SEWAGE DISPOSAL TESTING

MARYLAND STATE DEPARTMENT OF HEALTH

HOWARD COUNTY

RE: C.C. Link Prop-

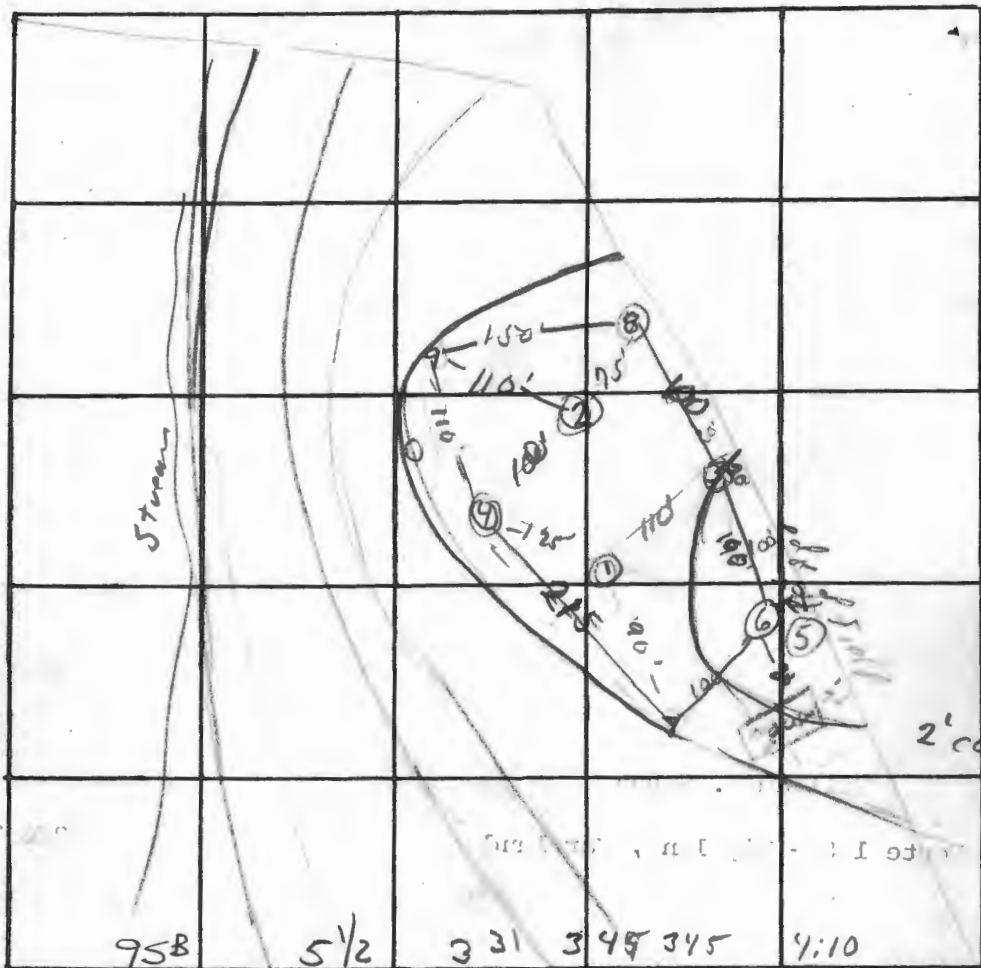
95A 4 1/2 315 X NO Perk

TYPE OF SOIL House site 1-2' lower than (6) well site problem

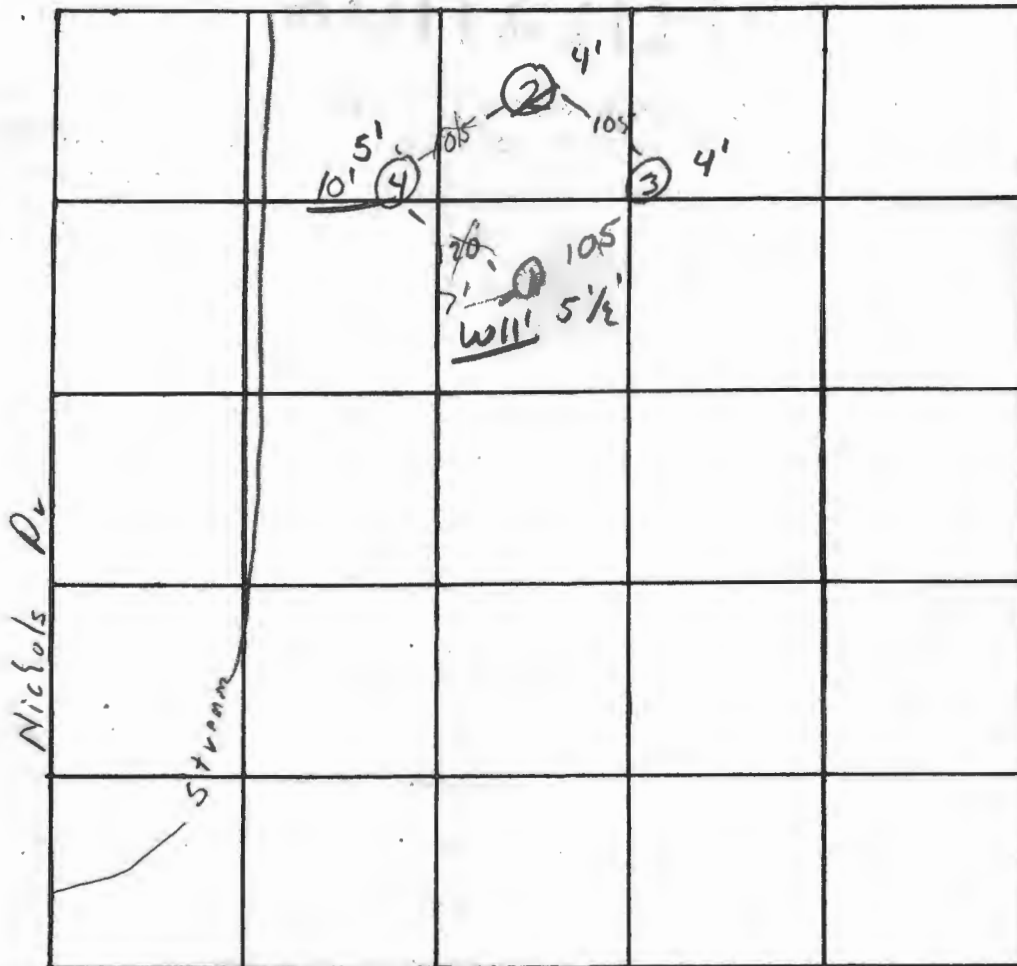
REASONS FOR REJECTION OR HOLDING This section tested of 32 acres
unsuitable for soil disposal system due to
high water table by 4/2/76

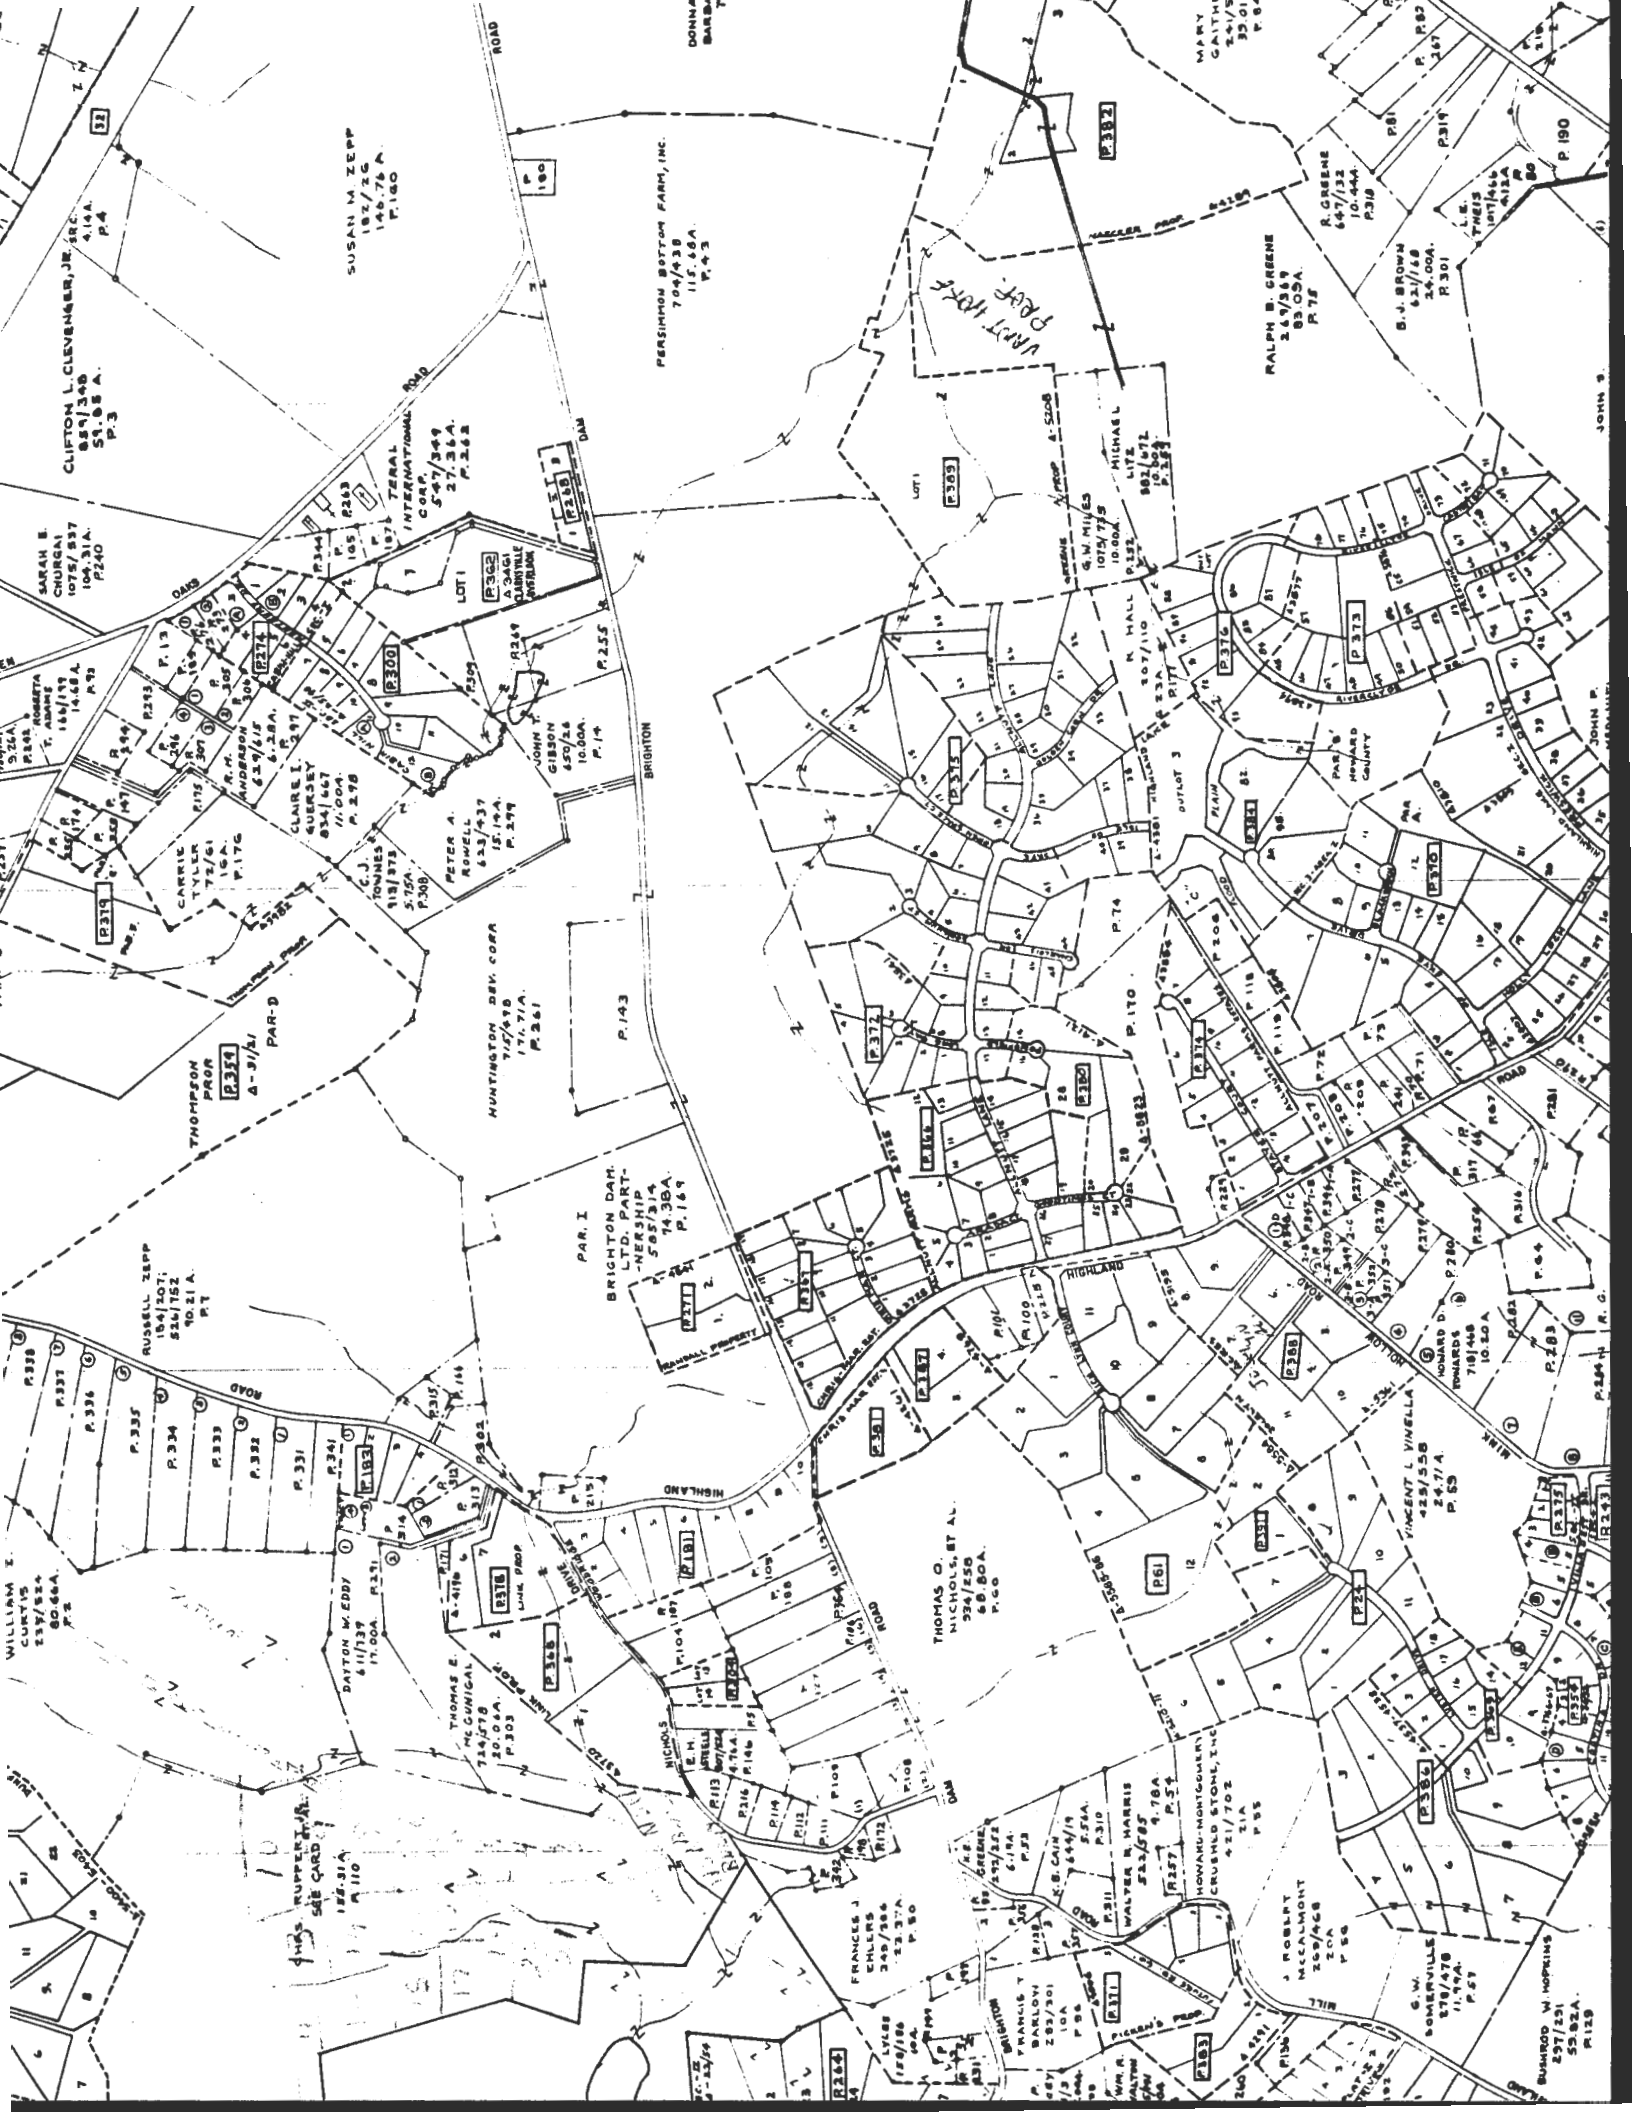
Spoke to Monaghan and Wini R.e. This lot
As it has been tested it will be difficult
To install a safe system.

We may pass this lot if the owner can
demonstrate 30-40,000 lb of this type of
ground. Additional tests are needed as
indicated below by *.

Also test near hole 1 at 3' depth,

Will need certified helix
if it passes.

TITLE PERCOLATION TEST PLAT - LOT 5			
PROJECT CLIFTON C. LINK PROPERTY			
LOCATION FIFTH ELECTION DISTRICT HOWARD CO., MD.			
DATE: 0/3/77	DES. BY:	DRAWN BY: W.N.	CHKD BY: R.M.
SCALE: 1" = 100'	JOB NO.: 7692	DRWG. NO.: 1 OF 1

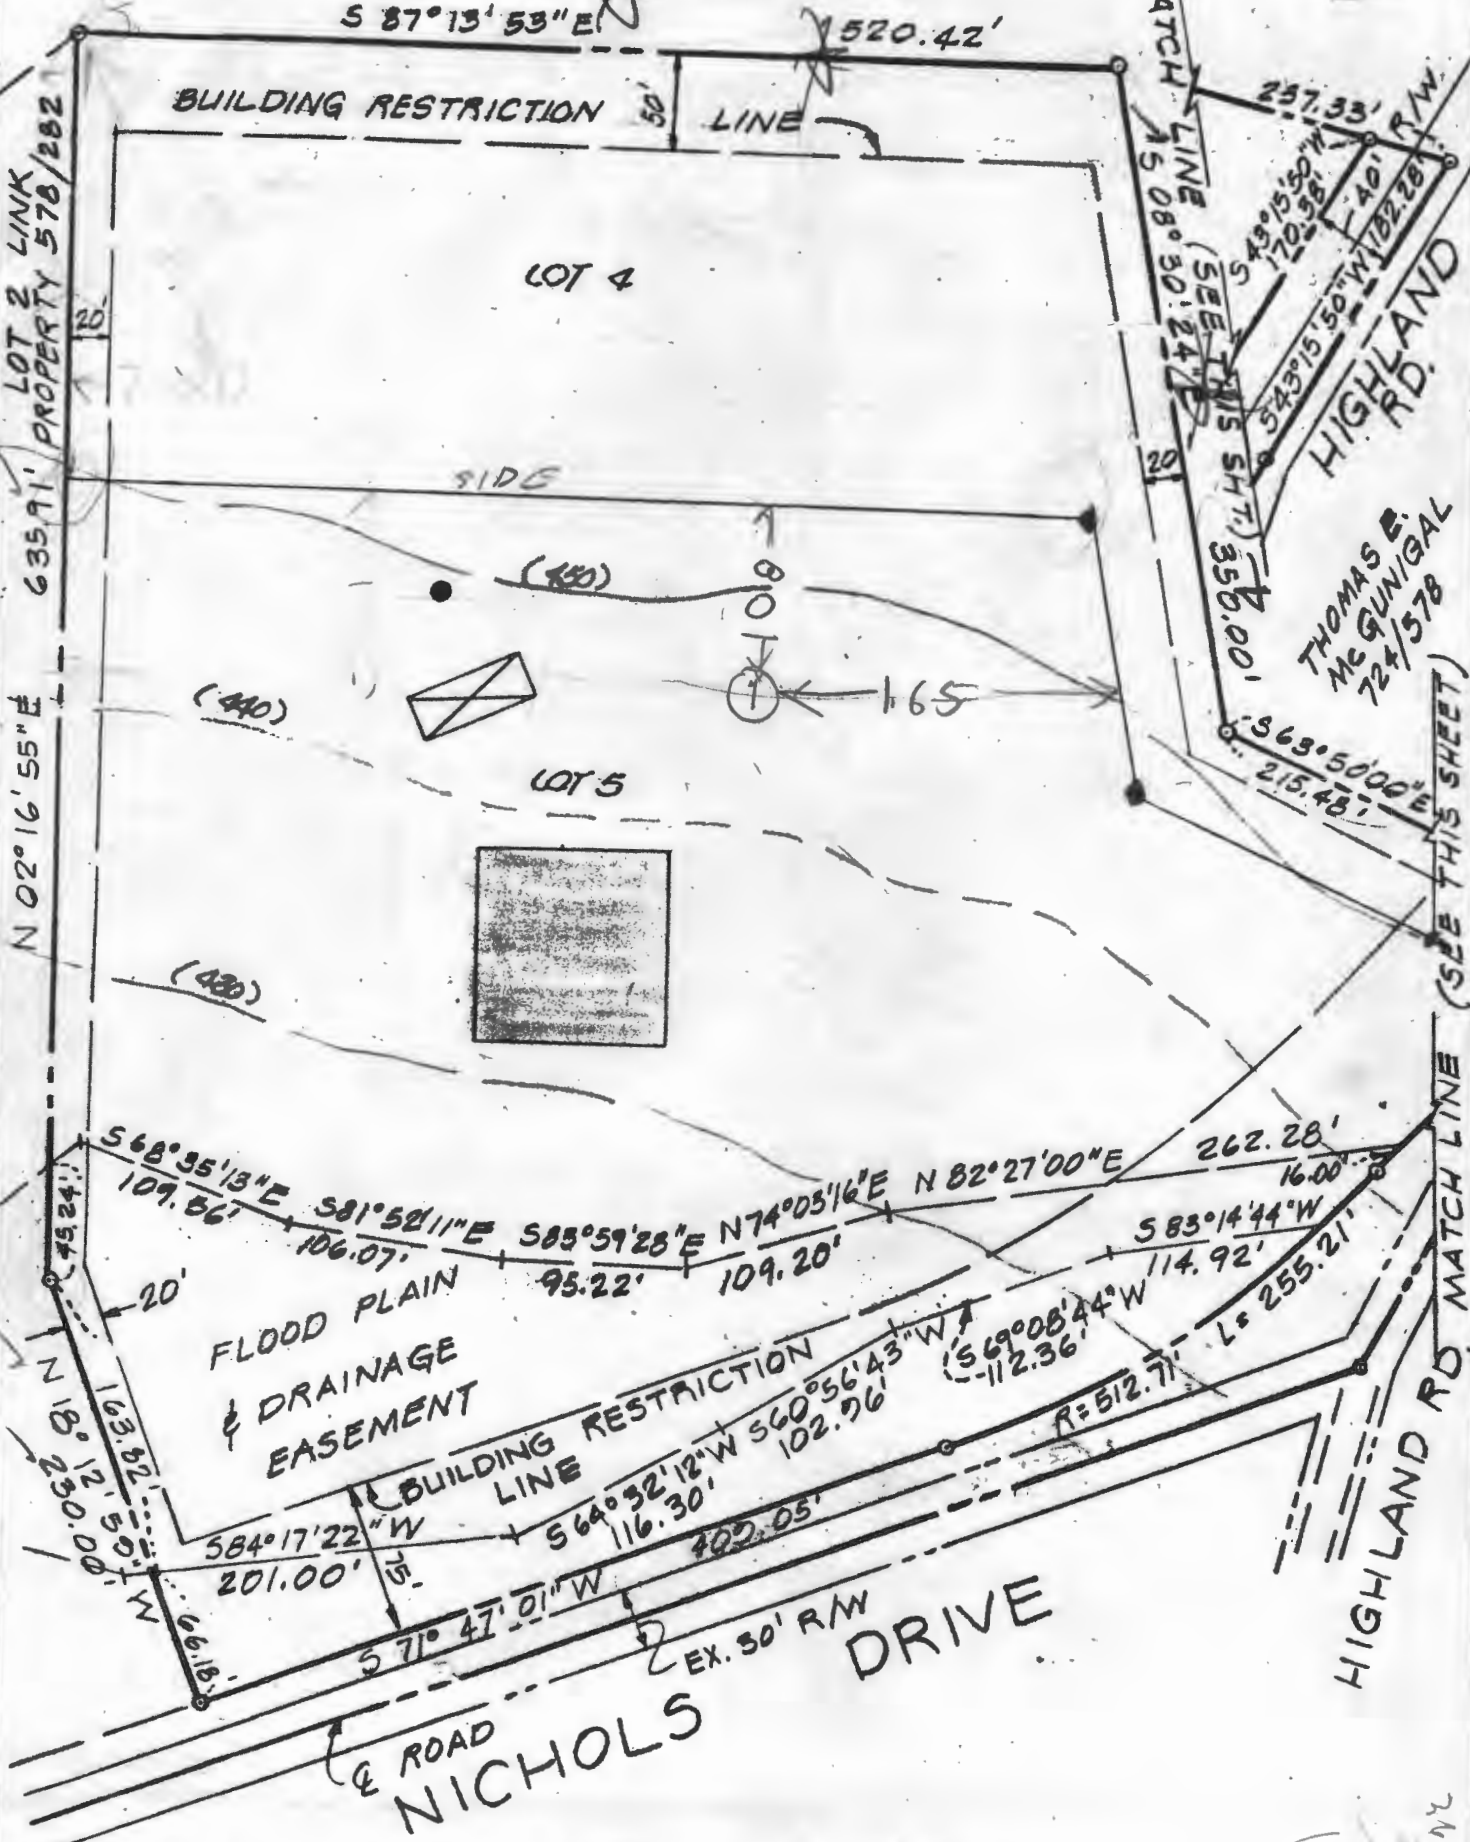
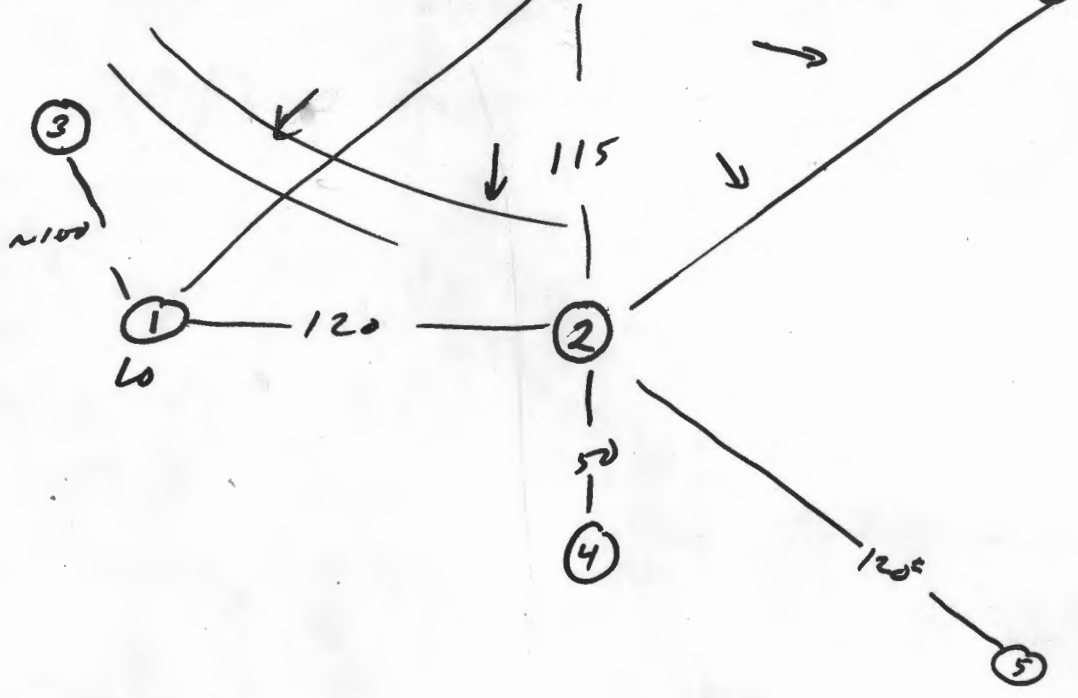
Must consult with
Engineer & find out
why sewage disposal
area of lot lines
changed

12/12/77 - FF & RH divider
perc was OK but
sewage disposal area
shown on plat does
not appear to be right
called Boulder Co &
left message to call RH

12/14/77 - Met Denver
official. Still confused
about perc area.
Necessary to have
field meeting 12/16/77
at 100 PM

12/16/77 - Made field inspection but
no one showed up for re-measurement
However I re-measured lot see other sheet
plat appears OK but must
discuss results

2/7/78 met with P. Rush & changed
sewage area slightly

2/8/78 P. M. said OK for Mr. Floyd to
sign final
